Vieux Carré Commission Architecture Committee Meeting

Tuesday, July 28, 2026

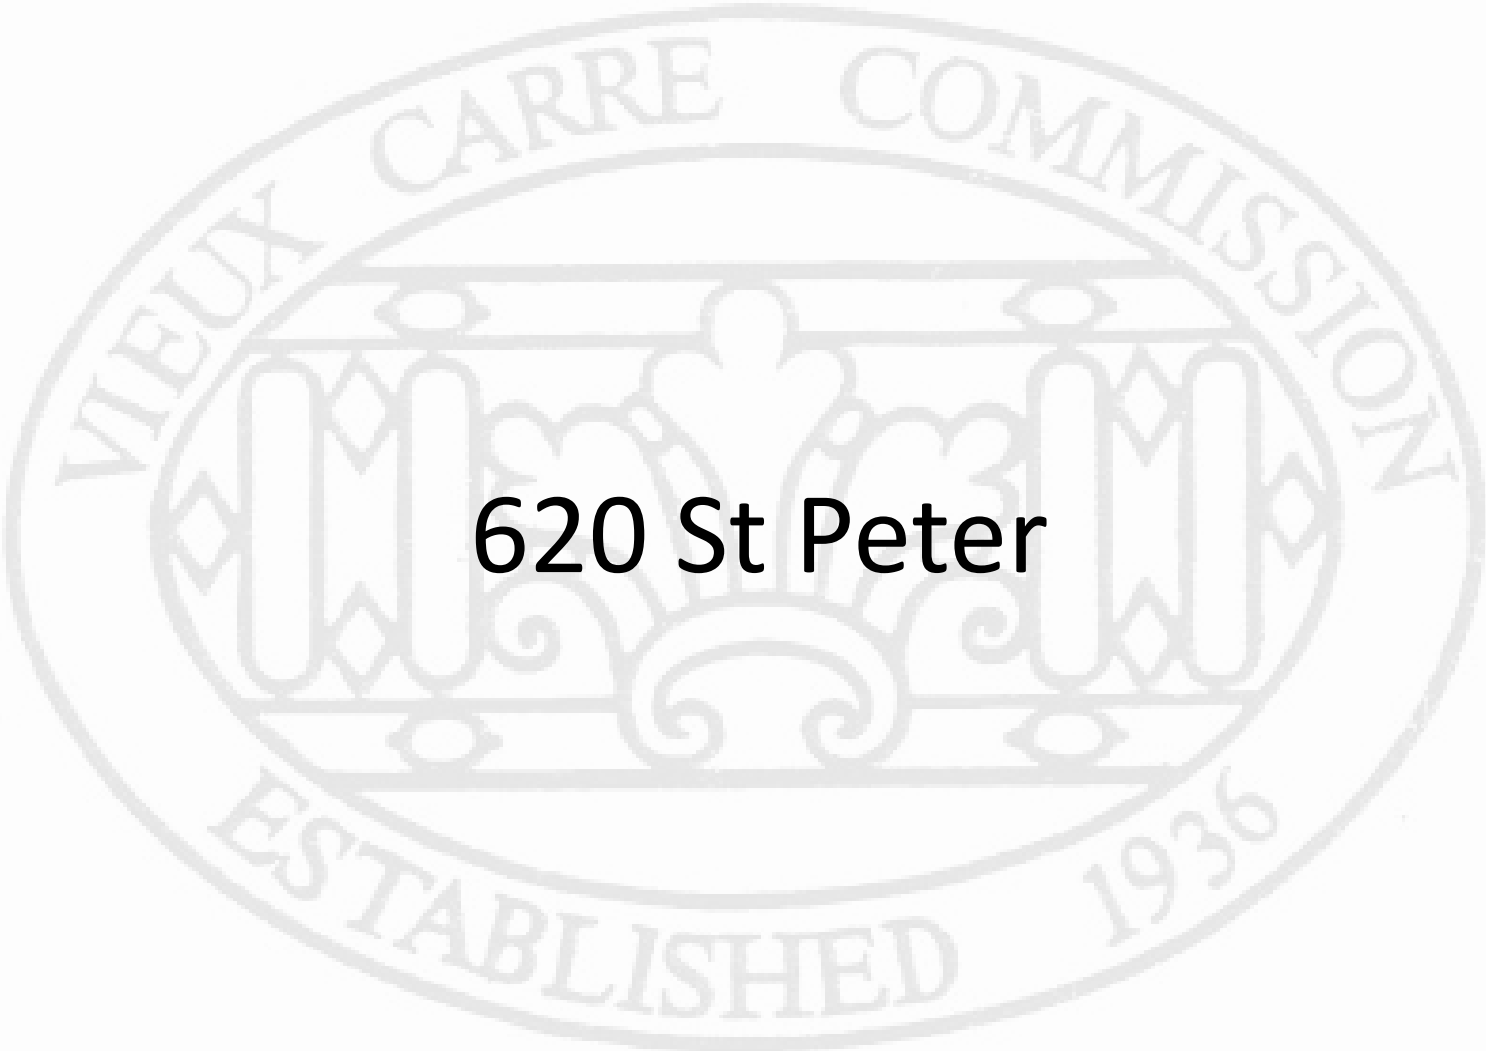
At the rear of the carriageway there is a brown-rated addition which consists of a built-out second-floor which is completely open air at the ground floor. Along the side property line, this addition is supported by four posts. Currently, two of these existing posts are steel while the other two are wood. The wood posts are suffering from deterioration and show evidence of questionable previous repairs. The applicant is proposing to replace the two wood posts with new steel posts to match the existing steel posts.

Based off photographs, staff believes that the two existing steel posts date to a late 2019 renovation, which was completed under prior ownership. Photographs dated to just prior to this renovation show a total of three posts, all appearing to be wood. The installation of the two existing steel posts was not included in the approved scope of work for that renovation, meaning the existing posts were installed without permit.

Still, staff notes that this is part of a brown-rated addition and potentially approvable. Staff also notes that if found to be necessary, these steel posts could easily be trimmed out in wood.

Given that this is part of a brown-rated addition, staff does not find the installation of the proposed steel posts to be objectionable and requests commentary from the Committee regarding the concept of installing wood trim around the steel posts.
